December 2017
FL743AB
NHTSA #17V-453 School Buses
#17V-454 Non School Buses
Transport Canada #17-359

Subject: TBB Wheelchair Pocket Track

Models Affected: Specific Thomas Built Buses Saf-T-Liner C2 school buses and non-school buses manufactured December 1, 2004, through May 30, 2017.

Wheelchair Pocket Track Reinforcement

Figure 1: Drilling Locations

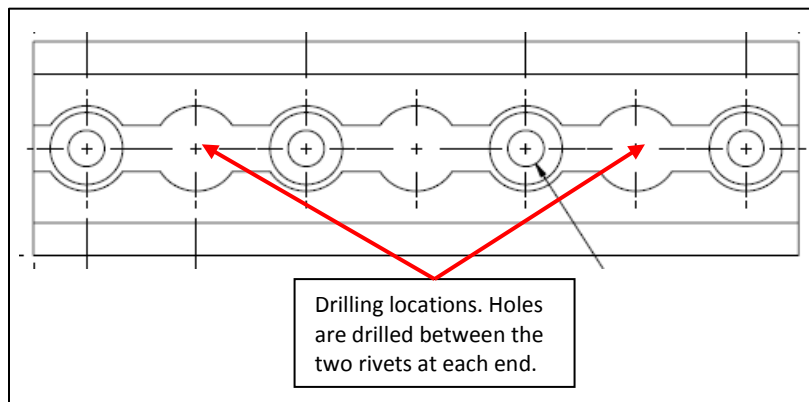
1. Park the vehicle, shut down the engine, make sure the shifter is in Park or Neutral. Chock the tires.
2. Identify track locations and prepare the area for installation of the bolts. (Seats covering the track, preventing installation of the two bolts may need to be removed.)
3. Drill a hole through the track and the floor using a "P" bit (.3230 in. bit). See **Figure 1** for locations.

4. Create a countersink in each of the holes drilled. This should be an 82-degree countersink at a .191 in. depth.
5. Insert a 5/16 in.-18 X 1.25 flat head socket cap bolt (TBB 184059) in each hole.
6. Underneath the bus, install a washer (TBB 69004114) and nut (TBB 69004121) on each of the bolts inserted through the track and floor and tighten to 12-14 lbf.ft.

Figure 2: Bracket and Bolt

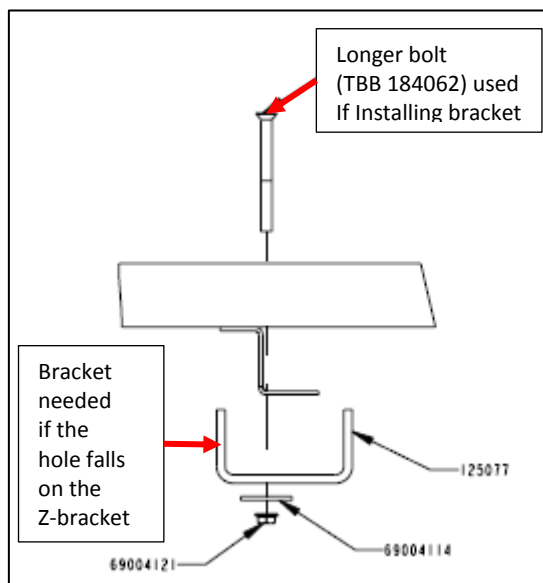
7. If the Z-section interferes with tightening the washer and nut against the floor, install a bracket (TBB125077) with a longer bolt (TBB 184062) over the Z-section as shown in **Figure 2**. If there is no interference, go to step 8.

8. Tighten each nut and bolt until secure against the floor and the bolt is flush against the top of the track.
9. Spray the new bolts with undercoating.
10. Repeat for each section of track.
11. Remove the chocks from the tires.
